Access Compliance Report

Public Rights-of-Way

(Curb Ramps)

Intersection ID: 10038802	Main Street: STEELE_CREEK_RD	Cross Street: N/A	Location: NW
ADA ID: 540EC55EDC71	Ramp Type: PerpDiag	Initial Pass/Fail: Fail	Overall Compliance: No
		Severity Score: 25

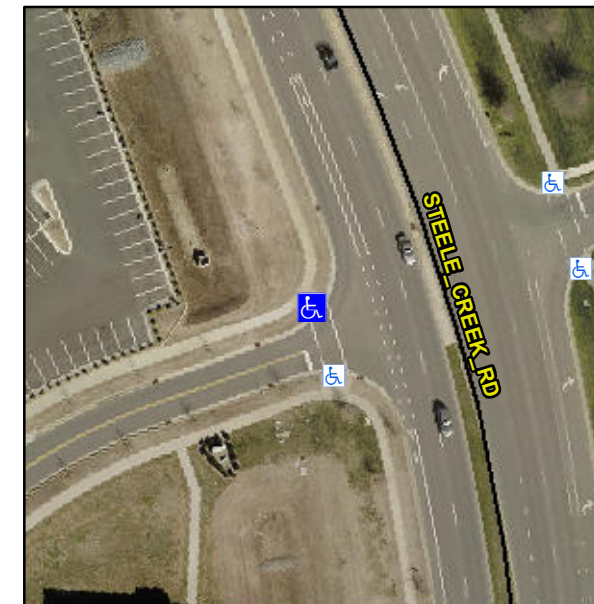
R304.2.2, R304.5.3

Compliance	Description	Data	Compliance	Description	Data
N/A	Ramp Length (in)	95.0	No	Ramp Slope (%)	8.5
Yes	Ramp Width (in)	48.0	No	Ramp XSlope (%)	5.5
N/A	Flare Type LT	N/A	N/A	Flare Type RT	N/A
N/A	Flare Slope LT (%)	N/A	N/A	Flare Slope RT (%)	N/A
N/A	Flare Traversable LT?	N/A	N/A	Flare Traversable RT?	N/A
N/A	Landing Length (in)	N/A	N/A	DWS Provided?	N/A
N/A	Landing Width (in)	N/A	N/A	DWS Contrast?	N/A
N/A	Landing Slope (%)	N/A	N/A	DWS Length (in)	N/A
N/A	Landing X Slope (%)	N/A	N/A	DWS Full Width?	N/A
N/A	Landing Curb? (Y/N)	N/A	N/A	DWS Offset (in)	N/A
N/A	Shared Landing?	N/A			
N/A	Gutter Ponding?	N/A	N/A	Gutter Slope (%)	N/A
N/A	Gutter Lip Ht (in)	N/A	N/A	Gutter X Slope (%)	N/A
N/A	Painted X Walk1?	Yes	N/A	Painted X Walk2?	No
	X Walk 1 Direction	To S		X Walk 2 Direction	To E
N/A	X Walk 1 Width (in)	112.0	N/A	X Walk 2 Width (in)	N/A
	X Walk 1 Slope (%)	1.3		X Walk 2 Slope (%)	3.0
	X Walk 1 X Slope (%)	6.5		X Walk 2 X Slope (%)	2.8

Remove & Replace Curb Ramp With Two New Directional Ramps or Equivalent.
